**PLANNING DEPARTMENT
CURRENT PLANNING STAFF ANALYSIS
PLATTING**

CASE: S12867
Holtan Hills Subdivision, Phase I,
Lots 1 through 19, Block 1, Lots 1 through 11, Block 2, Lots
1-9, Block 3, and Tracts 1A and 1B

REQUEST: Subdivision of one (1) tract into thirty-nine (39) lots and two (2) tracts with the following variances:

RECOMMENDATION: Approval of the Plat, Phasing Plan, and Variances 1, 2, 3

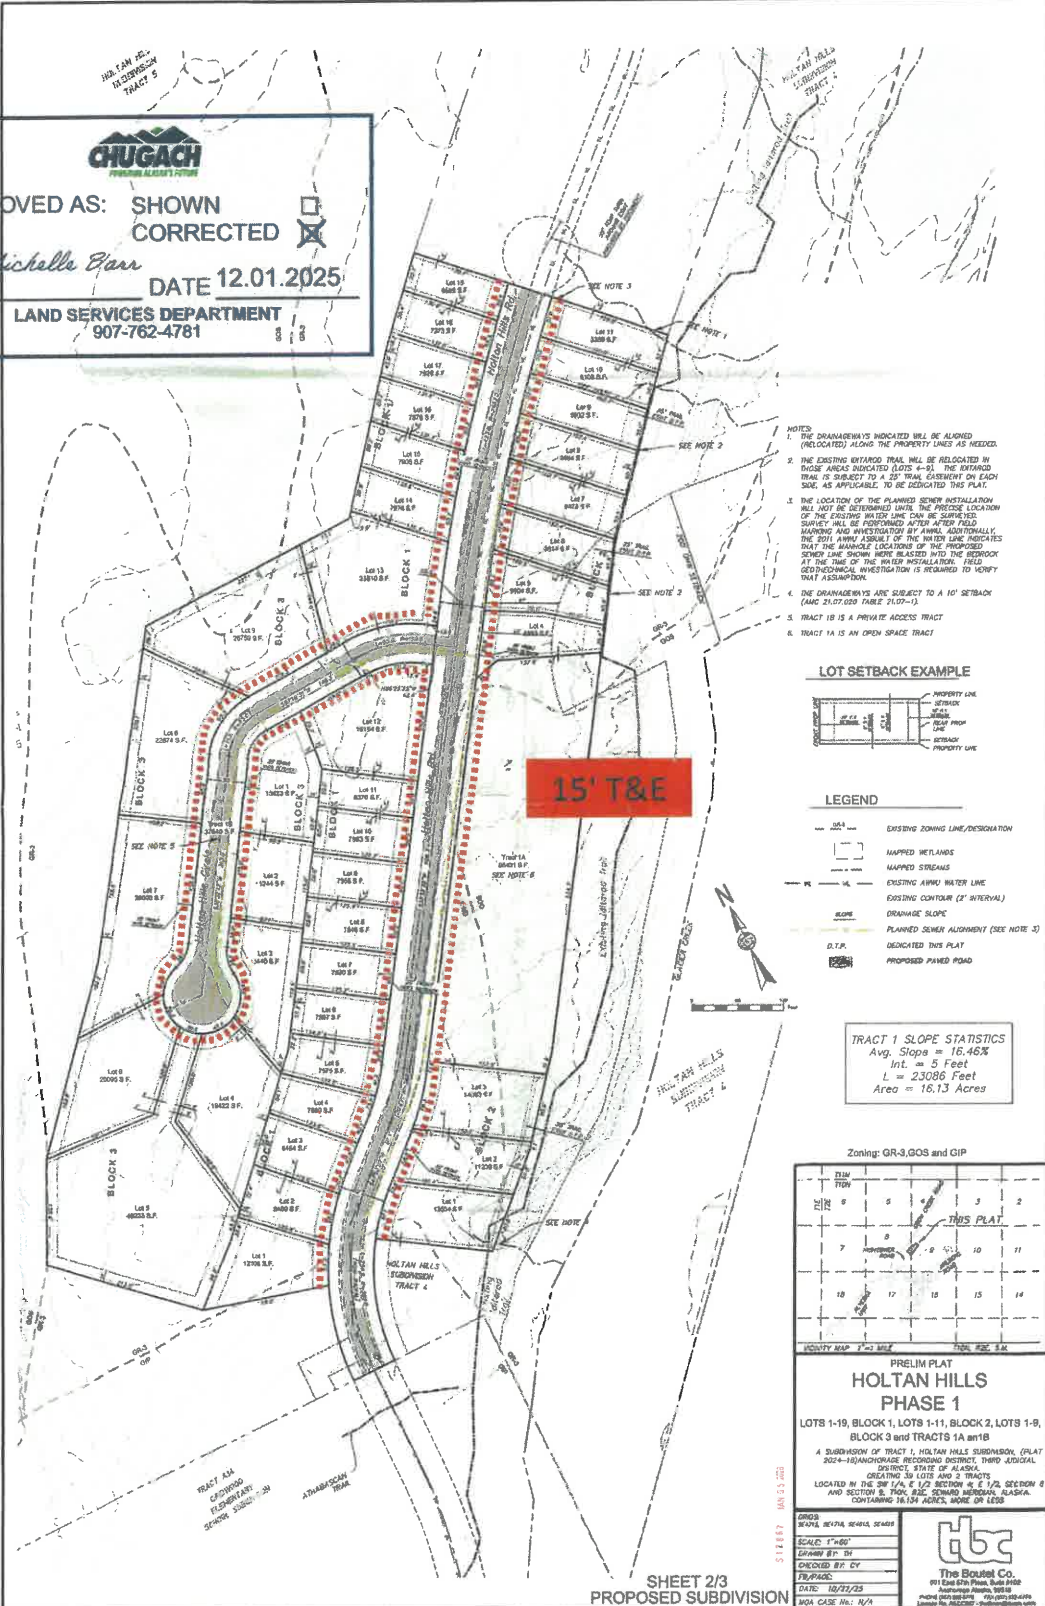
Chugach has the following comments:

1. Chugach has no objection to the preliminary plat of Lots 1-19, Block 1, Lots 1-11, Block 2, Lots 1-9 Block 3 and Tracts 1A and 1B, Holtan Hills, Phase 1 Subdivision, a re-subdivision of Tract 1, Holtan Hills Subdivision (Plat 2024-18)
2. New 15' T&E easements are required along both sides of the proposed Holtan Hills Circle and Holtan Hills Road boundary lines of the preliminary plat.

APPROVED AS: SHOWN
CORRECTED
